## Comments and Responses

This chapter presents the responses to all comments received on the Draft EIR for the proposed project. They are organized into four categories: General Public Comments, Public Agency Comments, Utility Agency Comments, and Other Groups Comments. Within each group, the letters have been numbered sequentially in alphabetical order.

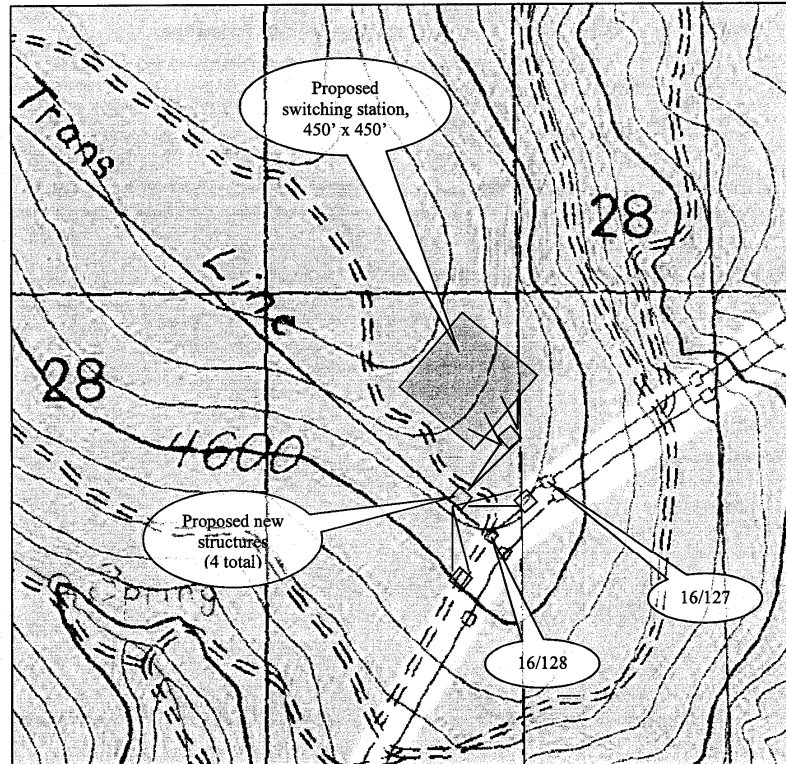
The Draft EIR incorrectly states that the size of the switching station will be about two acres. PG&E's need for the switching station area is roughly 450 feet by 450 feet or about 4.6 acres. I'm enclosing a drawing that shows our conceptual layout for the switching station and interconnecting 230kV loop transmission line.
